London Cycling Campaign is the capital's leading cycling organisation with more than 12,000 members and 40,000 supporters. We welcome the opportunity to comment on proposals for Cycle Superhighway 1.

### **Section 1: Sun Street - Paul Street (south)**

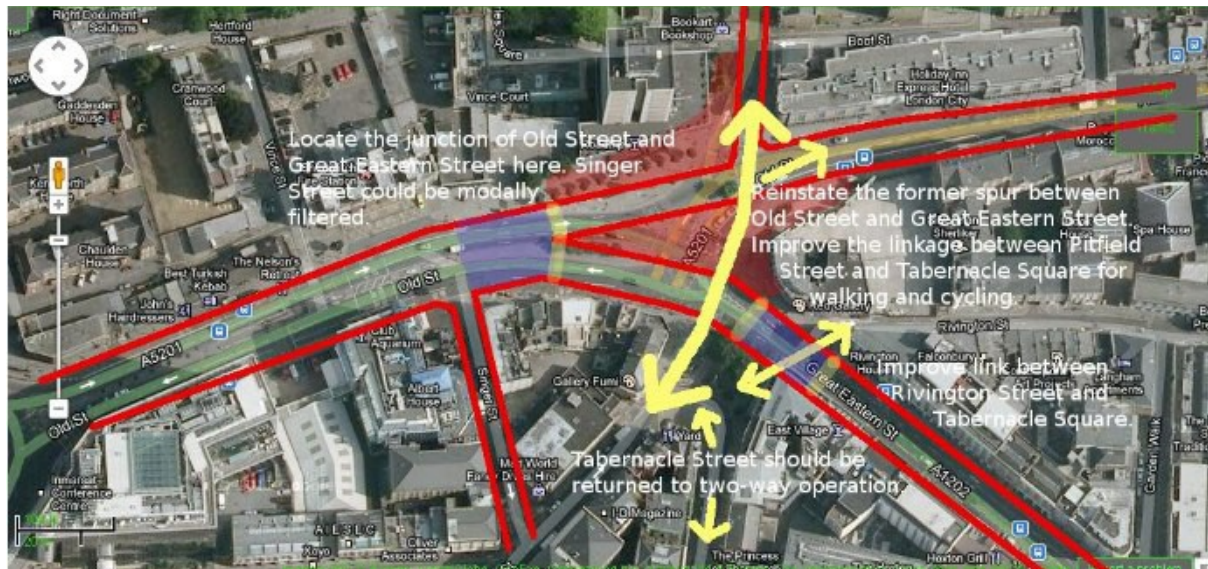
- Right turn from Pitfield street to Old st not supported, linked to heavy cycle flow westbound on Old st. Cyclists would have to informally merge with westbound motor traffic from Old St.
- The proximity of the pedestrian and cyclist crossings to a relatively small area on the peninsular will cause cyclist/pedestrian conflict, especially for any pedestrians attempting to access Old St, east, southside or Great Eastern St. northside and Rivington St.
- There don't appear to be "jug-handle" resting areas for cyclists making two-stage right turns from Old st west bound

The diagram below shows some ideas for supporting the main cycle flows at this junction. The problems with the junction could be solved by moving the interaction point of Great Eastern Street and Old Street further west and unbundling it from Pitfield Street. Removing the right turn from Great Eastern Street into Pitfield Street would permit lengthening the 'spur' further west, allowing

cyclists to pause there in the two-stage crossing, and would also allow a better location for the pedestrian crossings here, minimising conflict at the same time. All arrangements would be much simpler, offering greater freedom of movement to cyclists in all parts of the junction while improving clarity and minimising conflict.

The proposed loading bay on the A5201 would need to be located west of Pitfield Street, not east of it. The proposed arrangements for the Rivington Street junction would also be considerably improved under such a scheme.
